## Avon Parks – Burnett Park and Winton Meadows Park Addendum 02

DATE: Friday, February 20, 2026

PROJECT NAME: **Burnette Park and Winton Meadows Park**

The extent of this addendum is as follows:

**1** WOODLAND POD: SIDE ELEVATION, CROSS SECTION, AND ISOMETRIC-ADD ALTERNATE  
Scale: 3/4" = 1'-0"

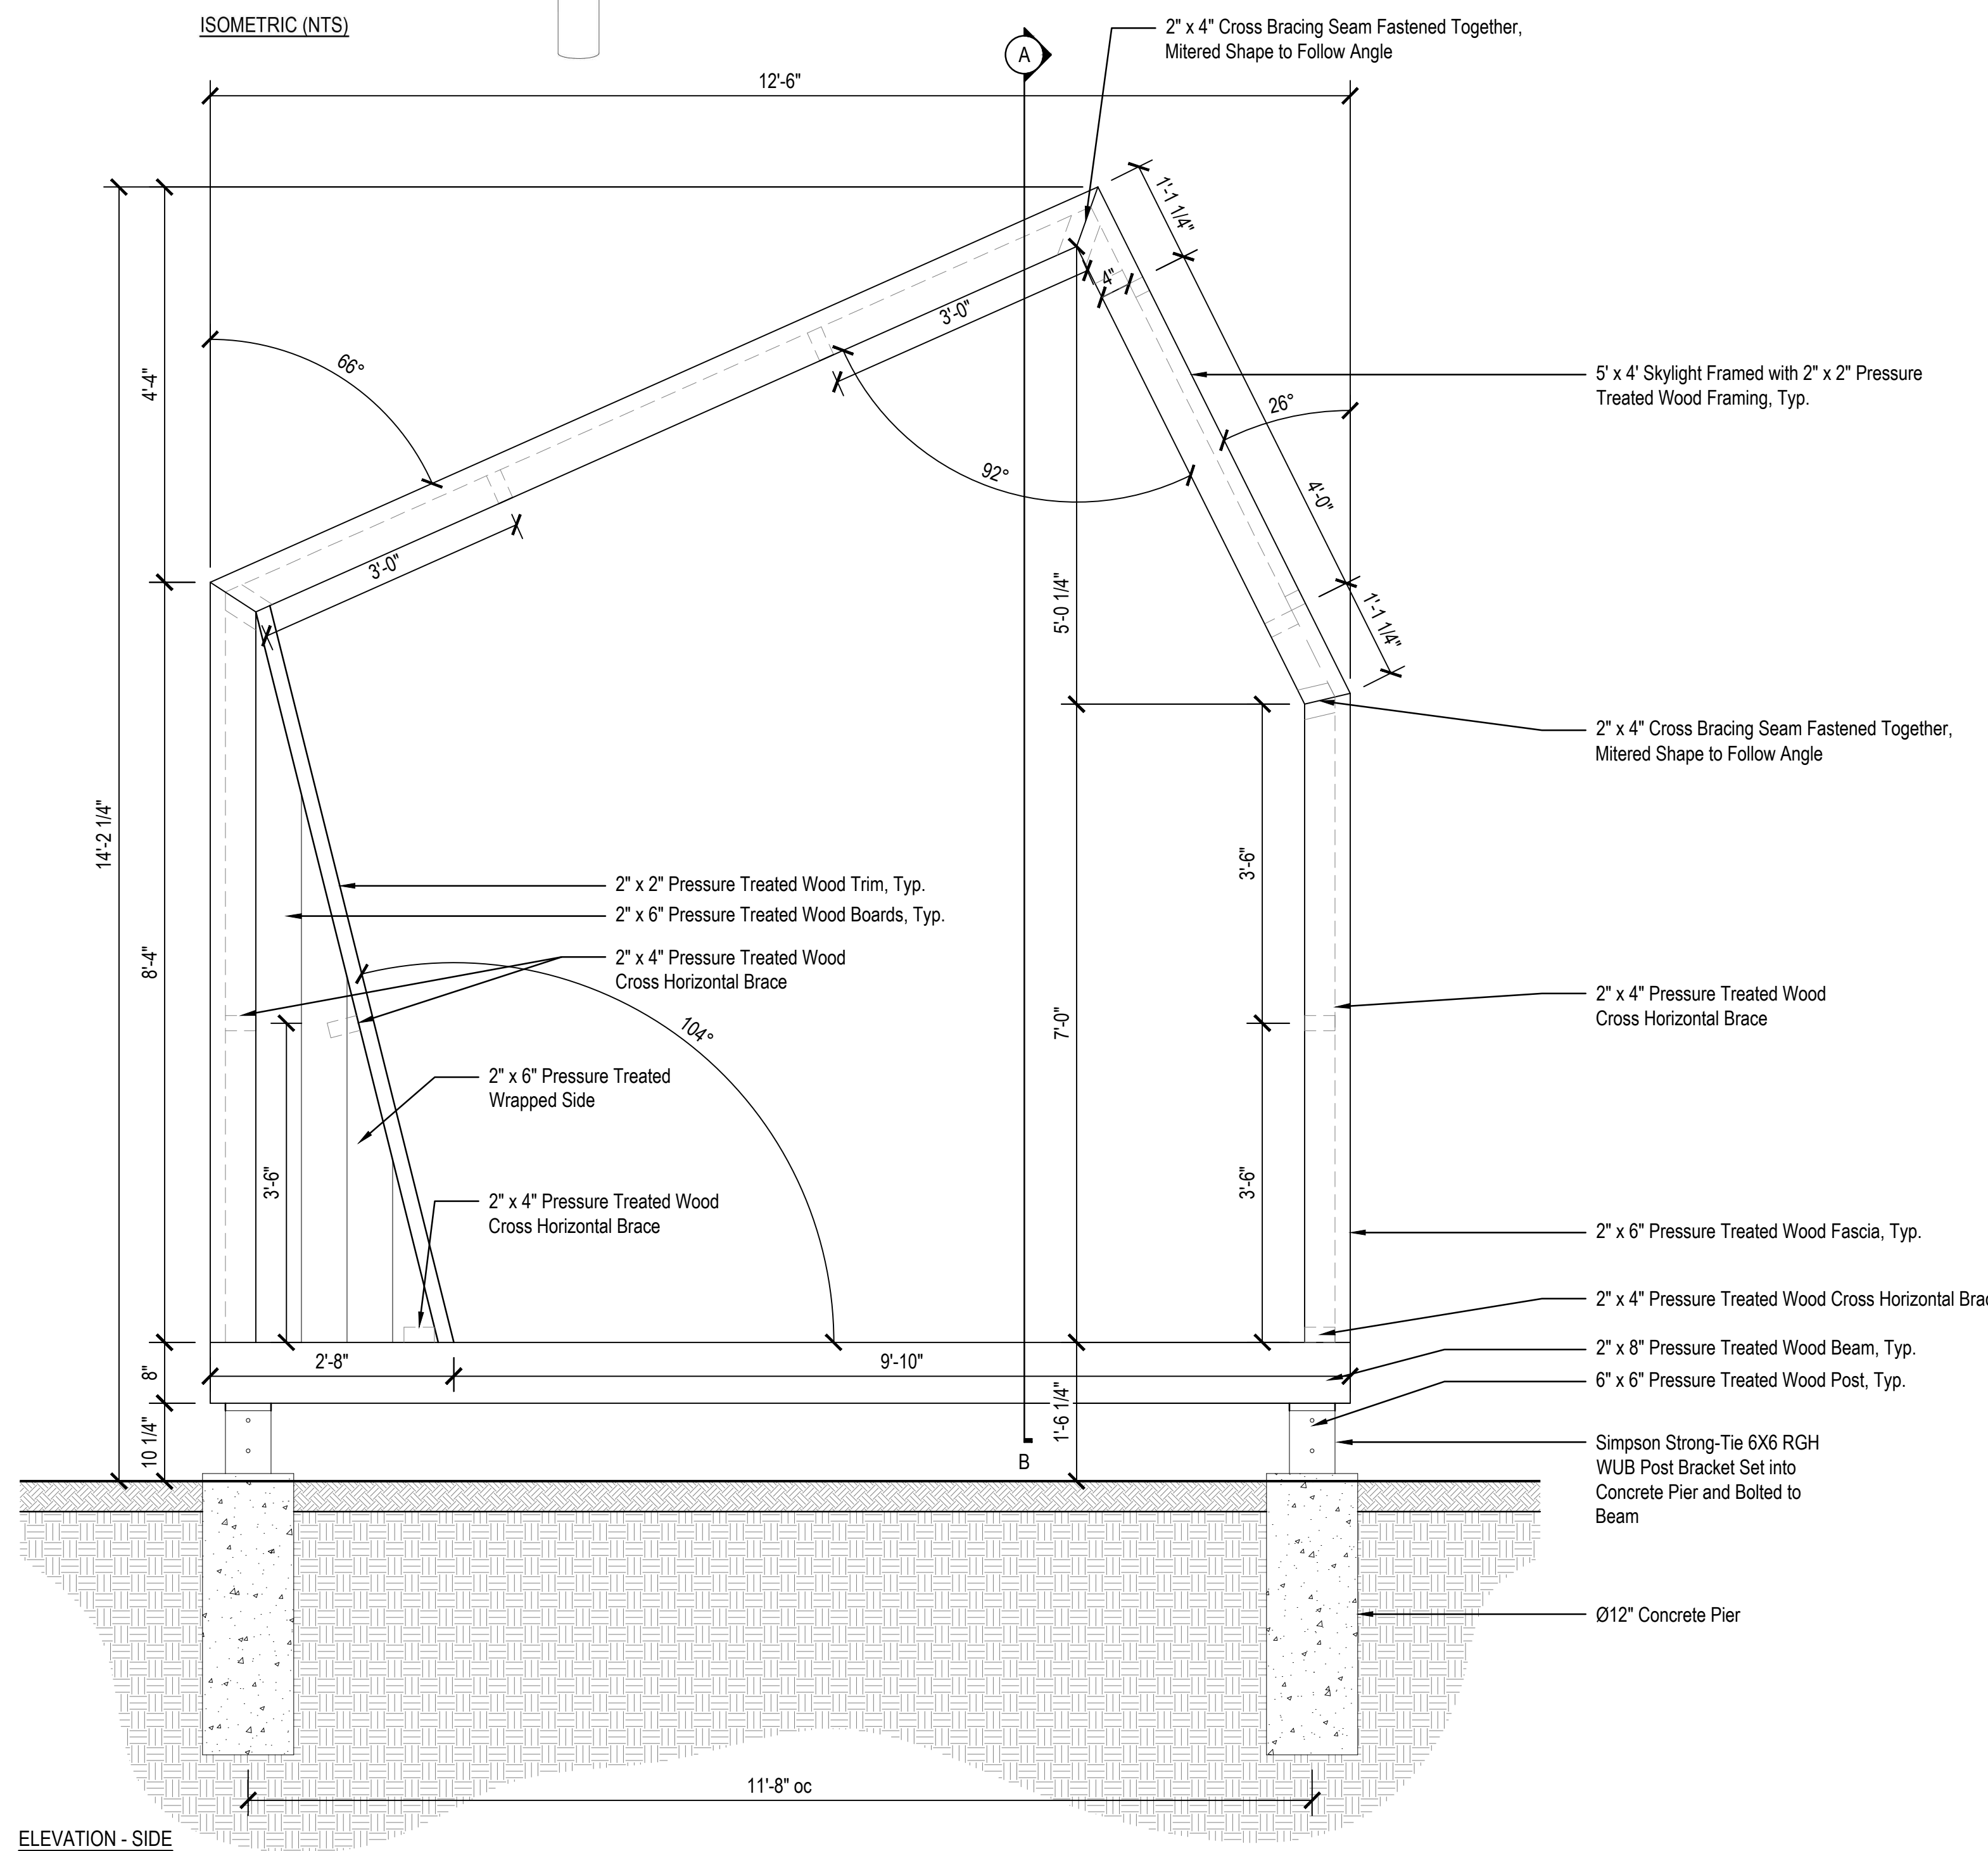
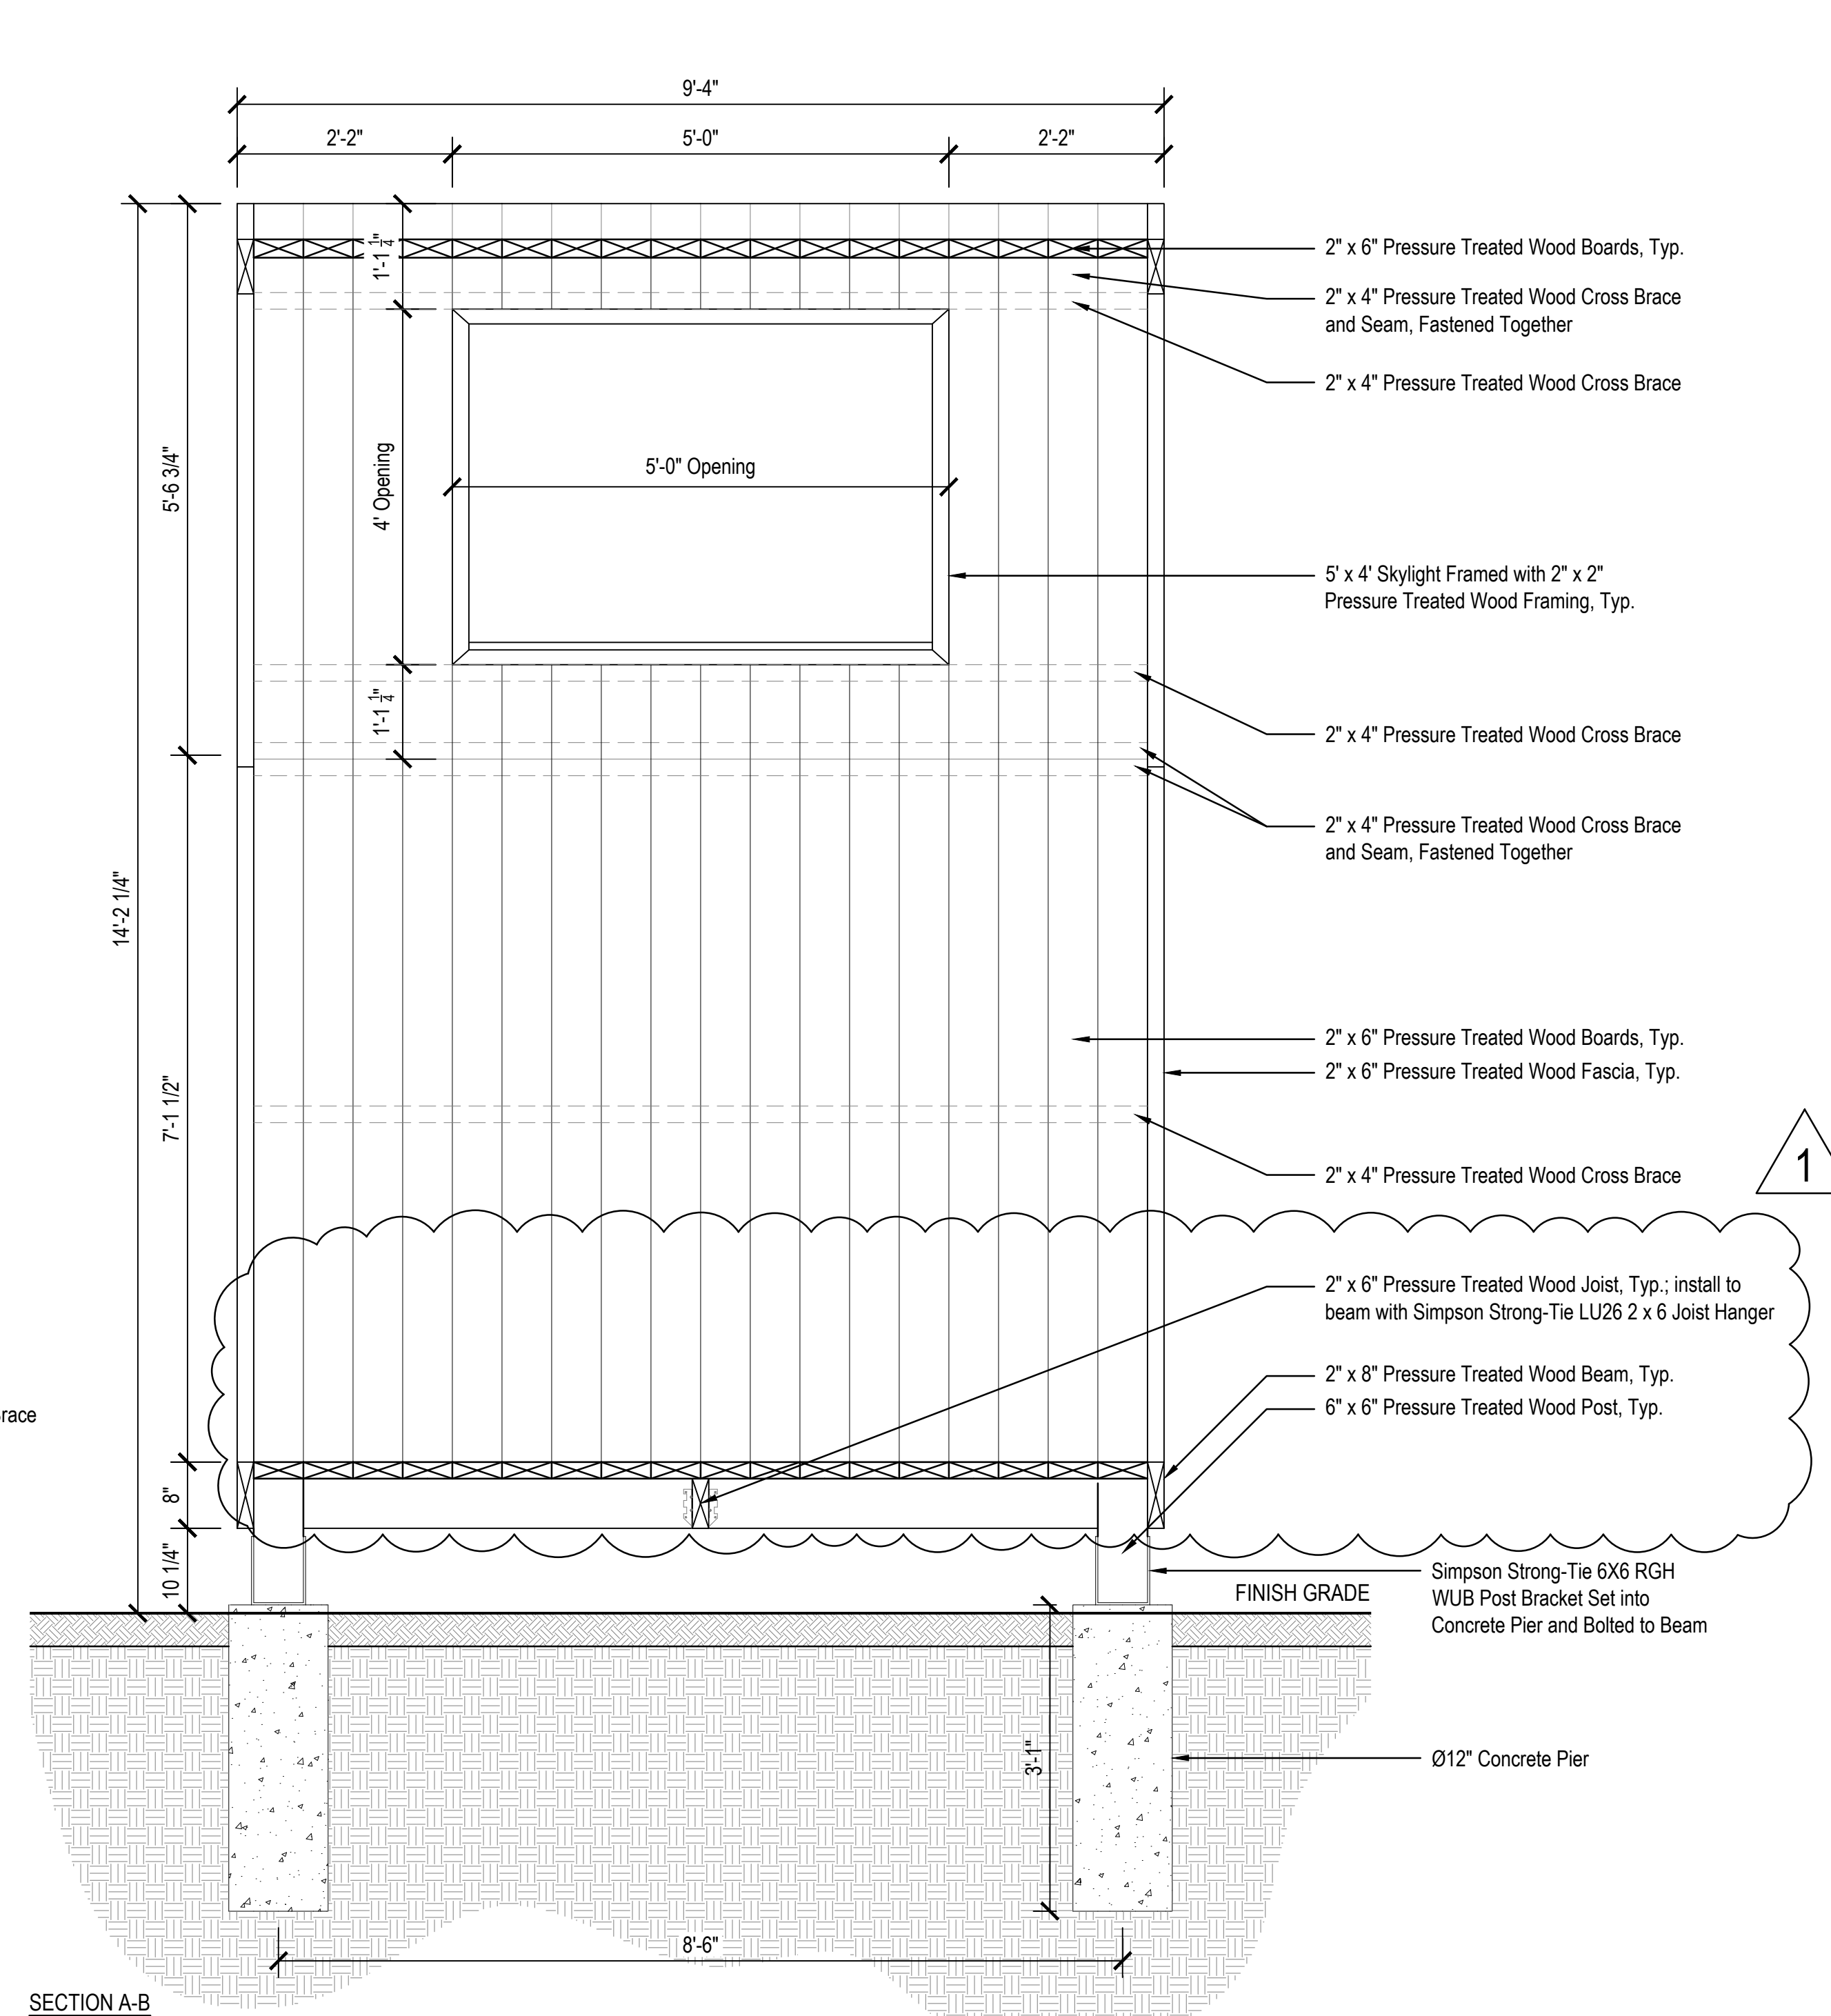
- a) Joists adjusted to be perpendicular to structure floorboards.
